**TOWN OF NEWBURGH
PLANNING BOARD
TECHNICAL REVIEW COMMENTS**

PROJECT NAME: DUNKIN DONUTS
PROJECT NO.: 14-02
PROJECT LOCATION: SECTION 14, BLOCK. 1, LOT 43
REVIEW DATE: 30 APRIL 2015
MEETING DATE: 7 MAY 2015
REPRESENTATIVE: JOSEPH MINUTA

Figure 3 - 2015 Existing and 2016 No-Build Traffic Volumes - Amended

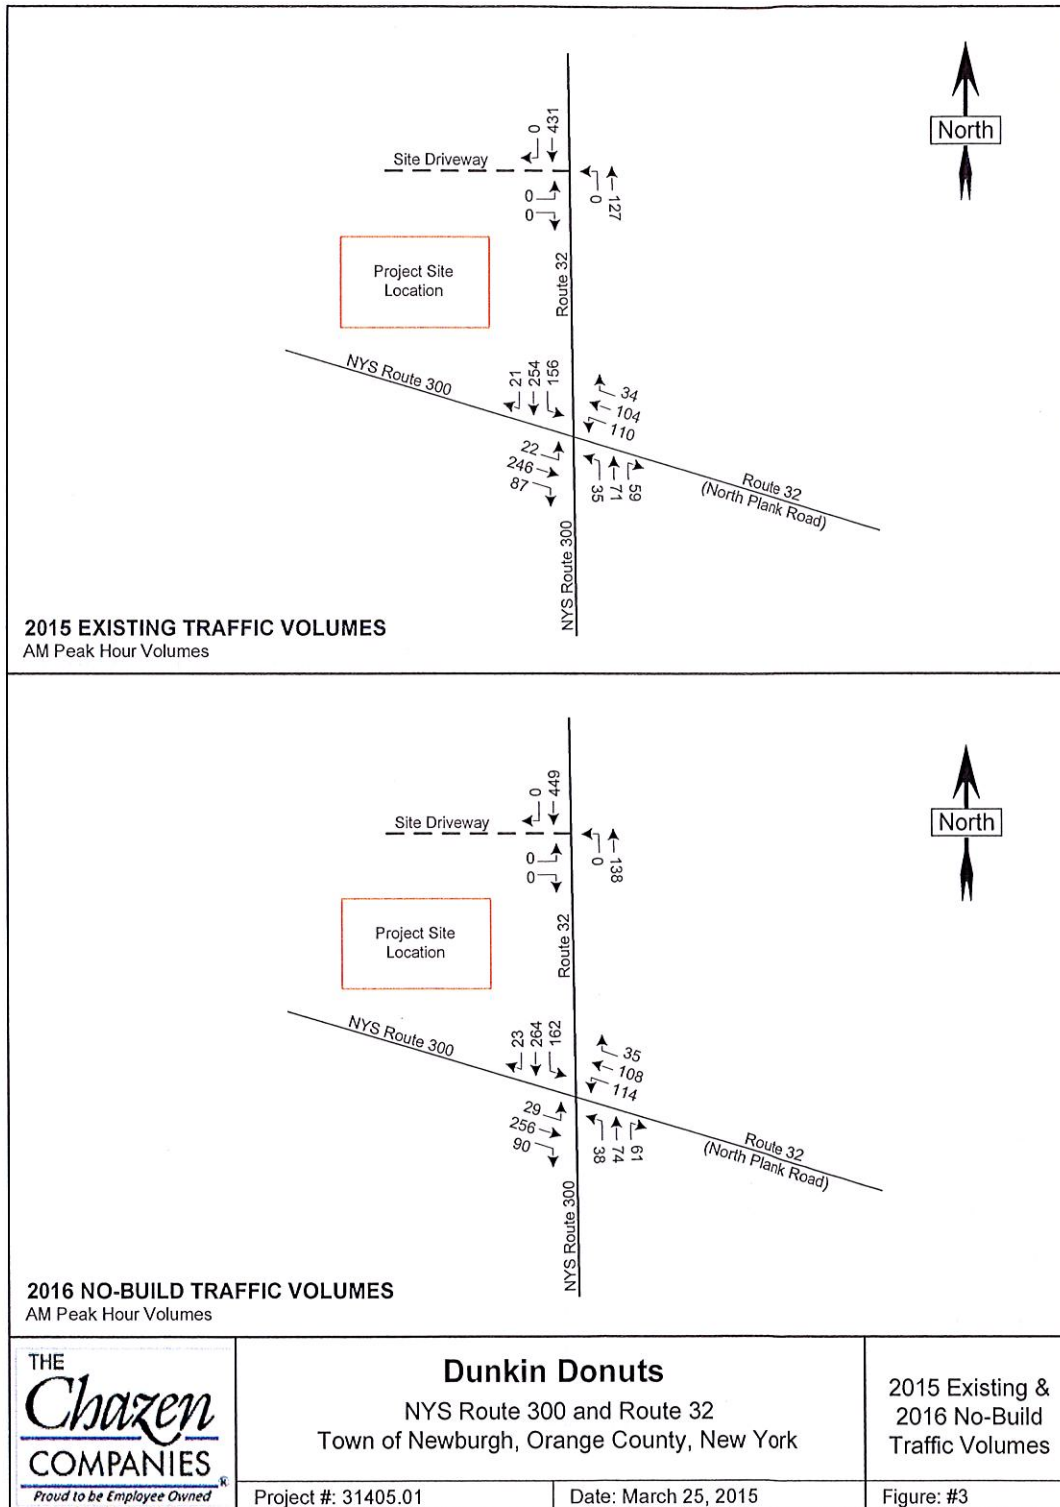
Comment 1: The No-build volumes utilize a 2% per year (for 2 years) growth rate and does not account directly for any other developments proposed/ approved in the area. Two residential projects (Driscoll and Polo Club), located south of the subject site have been approved for several years but have not been constructed. We reviewed our files to identify how much traffic was estimated to travel through Route 300/32 intersection from these projects; 36 trips total during the AM peak hour. The Dunkin Donuts analysis utilizing just the growth rate includes 49 additional trips. Therefore, use of the 2% growth rate would include the projected traffic from the Driscoll and Polo Club projects. It is noted that the No-build volumes on Figure 3 for the northbound approach to the signal are transposed between the left and right turn lanes, which is carried over to the Build volumes (Figure 4).

Response: *The use of the 2% growth rate discussion has been expanded to include discussion of the noted two specific projects. Traffic volumes for the No-Build figure have been corrected.*
